# SOLID WASTE MANAGEMENT SERVICES RFP NUMBER 22-005

Questions in "Black"; Answers in "Red"

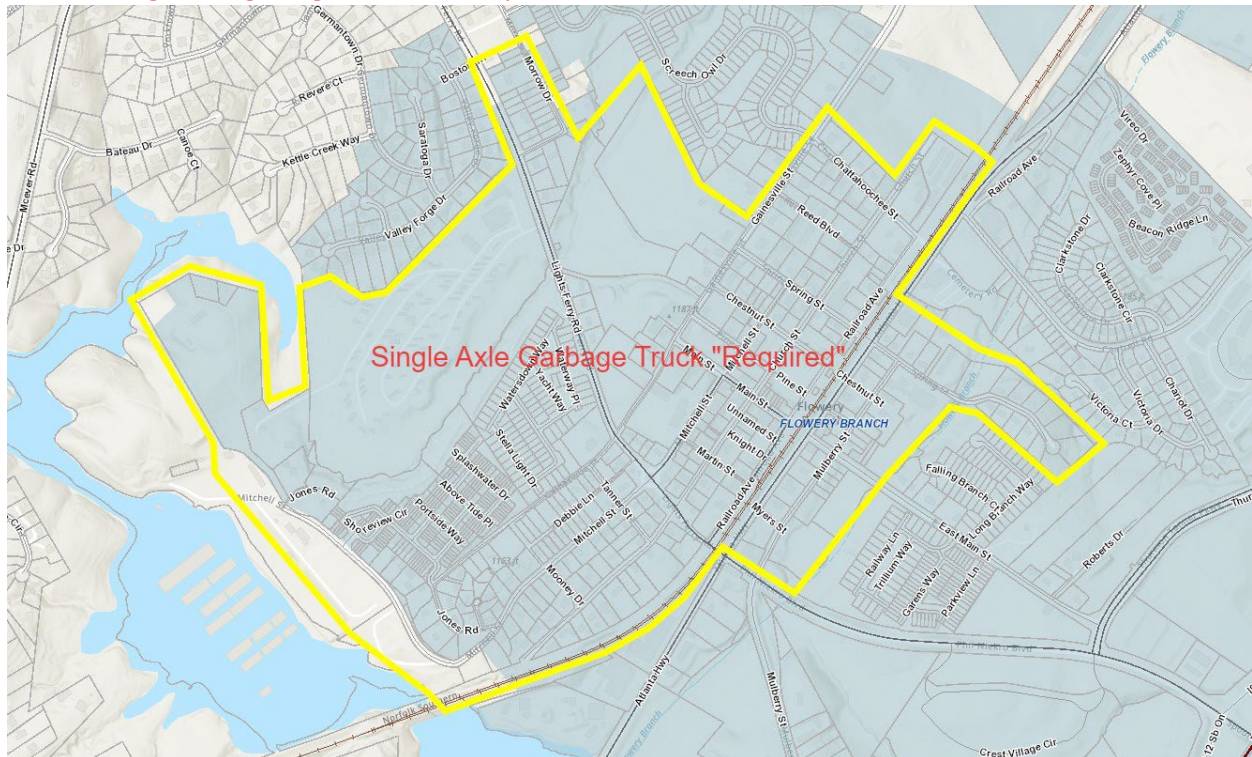
Question: Could you send me a map showing the streets that the city is going to require single axle only trucks?

Answer: Single axle garbage trucks are required as shown below.
